FXi 60/250 Exciter

Power Supply Q10 Upgrade Application Guide

597-0541-011
Revision B
November 11, 2011

Figure 3 – Early version, will need additional capacitor added.

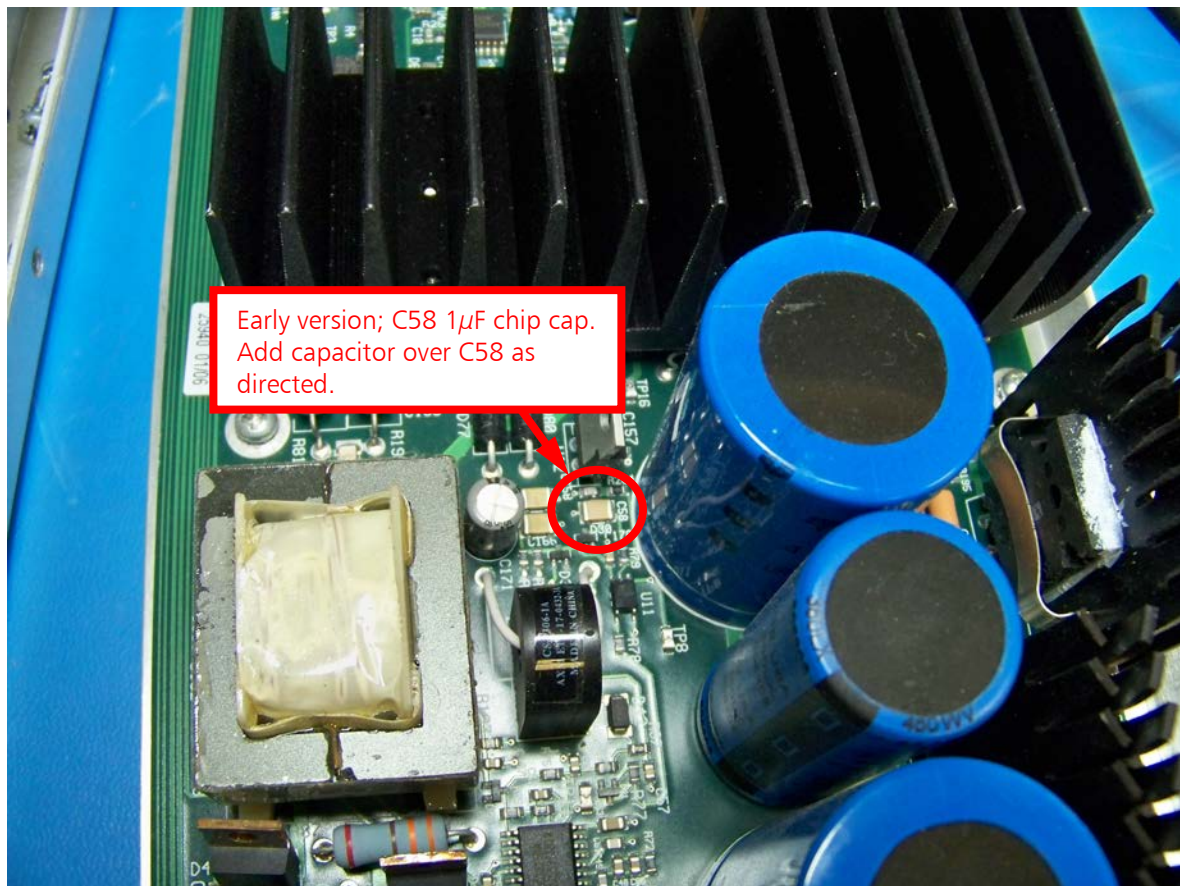
In addition to the Q10 replacement, users are also required to update the power supply by ensuring C58 contains a 22 μ F capacitor. NOTE: A 22 μ F C58 capacitor is required to prevent a pulse from U12 which will destroy Q10 during AC power off cycle.

Not all units will need this capacitor added. Early versions have only a 1 μ F capacitor chip cap (see Figure 3) and will need the additional capacitor added.

Install 22 μ F capacitor 020-2273 over the 1 μ F chip capacitor, note polarity of capacitor!

Figure 4 – Board manufactured or factory serviced since May 19, 2008 with the capacitor already added. This will be noted by a sticker on the board "Dev. 1178." No additional capacitor is needed.

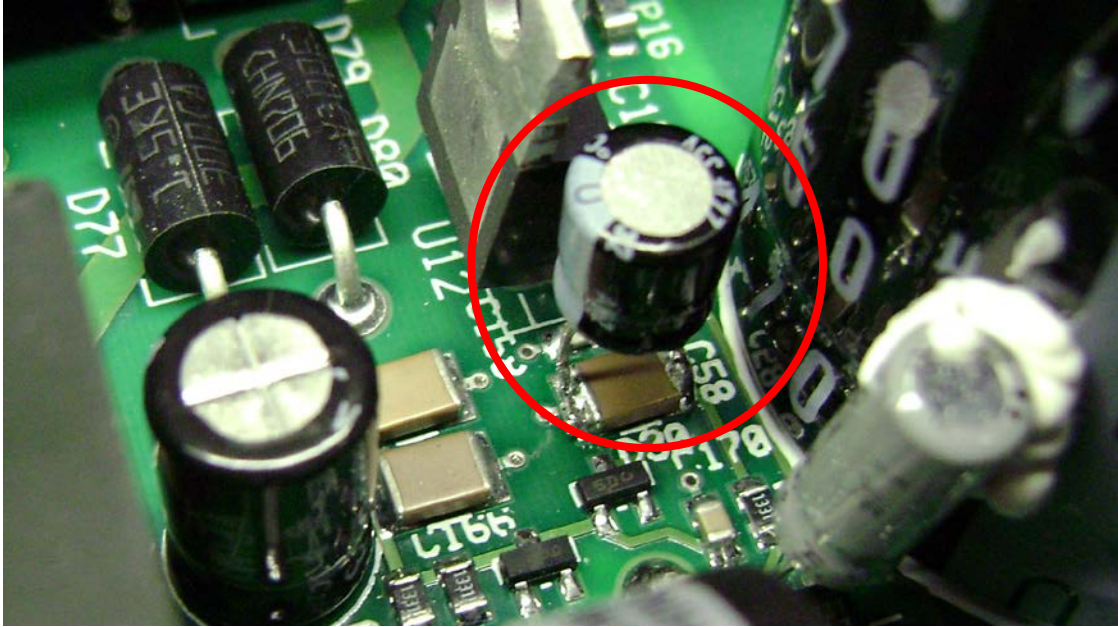
Boards manufactured, or factory serviced since May 19, 2008 have the additional capacitor added (see Figure 4), no additional capacitor will be needed. On board revision AB or newer, the capacitance has been increased on the on-board capacitor, no modification will be needed.

Figure 6 – Capacitor leads bend for soldering to C58.

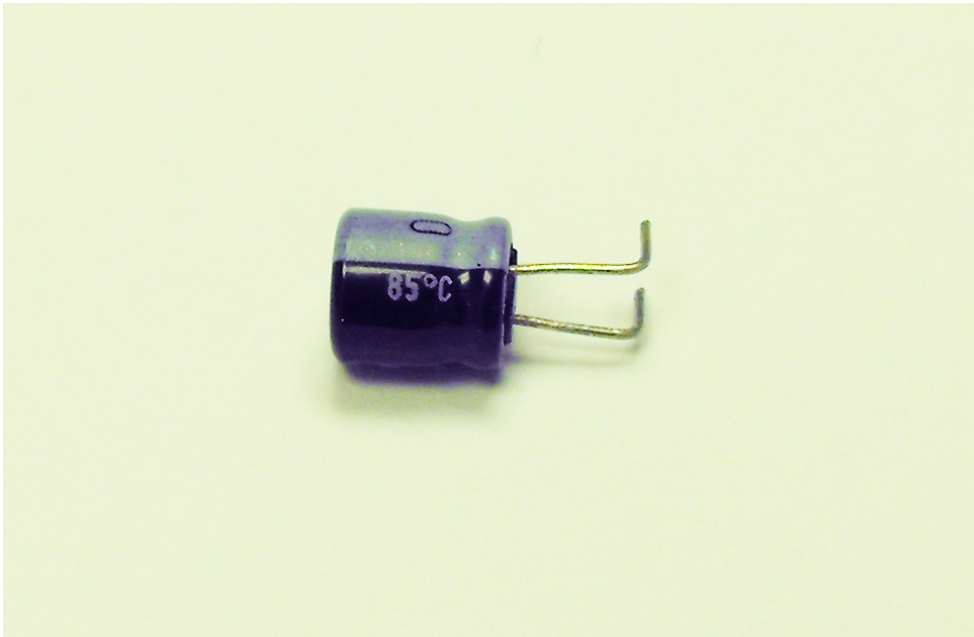
Bend the leads at 90° as shown in figure 6. Position the capacitor so the negative lead is farthest away from the large 470 μ F 450 volt capacitor as shown in figure 4. Carefully solder the leads to C58.

Figure 12 – FET leads formed for board insertion.

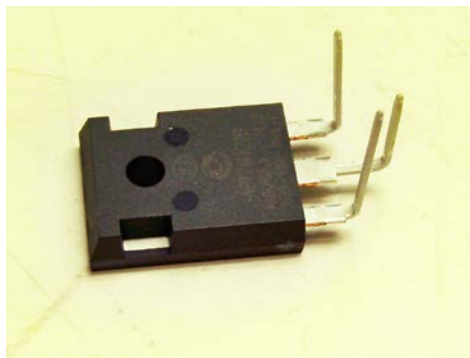
Use Part number 210-1201 forming the leads like the device being removed, reuse the existing thermal pad insulator or replace with supplied thermal pad insulator as needed. Insert FET into board, do not solder yet.
